Item ID: D206-642-341BL

Item Name: Replacement Skidtube (Fits LH or RH)

DRAWING NO. D2650	TITLE 206/407 SKIDTUBE ASSEMBLIES	REV. F	DART AEROSPACE LTD ENGINEERING ORDER		D.E.O. NO. D2650-F-1	SHEET NO. SHEET 1 OF 1	SCALE NTS
DRAWN <i>JP</i>	CHECKED <i>A.P.</i>	MFG. APPR. <i>AA</i>	APPROVED <i>HA</i>		DE APPR. <i>HA</i>		
DATE 12.10.12	DATE 12.10.22	DATE 12.10.22	DATE 12.10.22		DATE 12.10.22

CHANGE C'BORED WELDED CROSSBOLT SPACERS TO SWAGED SPACERS

DETAIL G

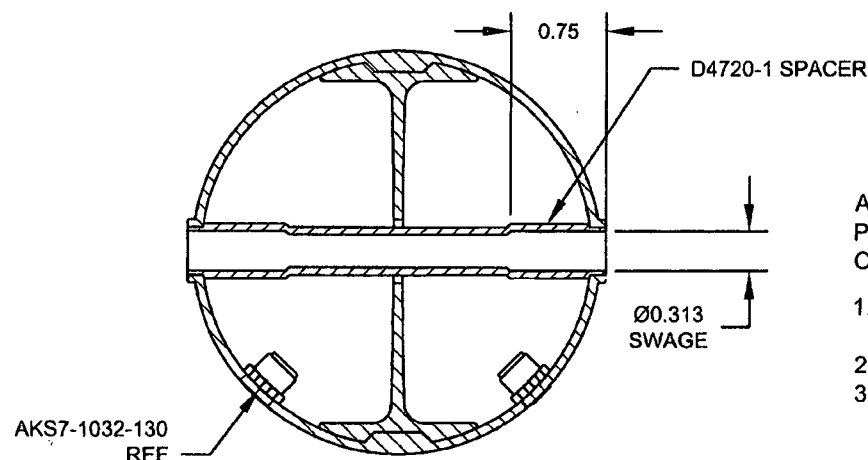
ADD DETAIL G BELOW, WHICH IS THE SAME SECTION VIEW AS DETAIL D OF DWG.

C'BORED HOLES ARE **NOW SWAGED** PER DETAIL G BELOW. FOR THE Ø0.375 HOLE THAT IS NOT C'BORED, WELD PER DETAIL D OF DWG (SEE AMENDED DETAIL B FOR REFERENCE).

AFTER DRILLING AND BENDING ASSEMBLY
PERFORM THE FOLLOWING FOR Ø0.375 HOLES THAT ARE
CURRENTLY C'BORED:

1. INSERT D4720-1 SPACER, 16 PL (-1) OR 17 PL (-3)
OR 19 PL (-5) OR 23 PL (-7)
2. SWAGE TO Ø0.313 X 0.75 DP PER QSI 002
3. TRIM / GRIND FLUSH PER QSI 002
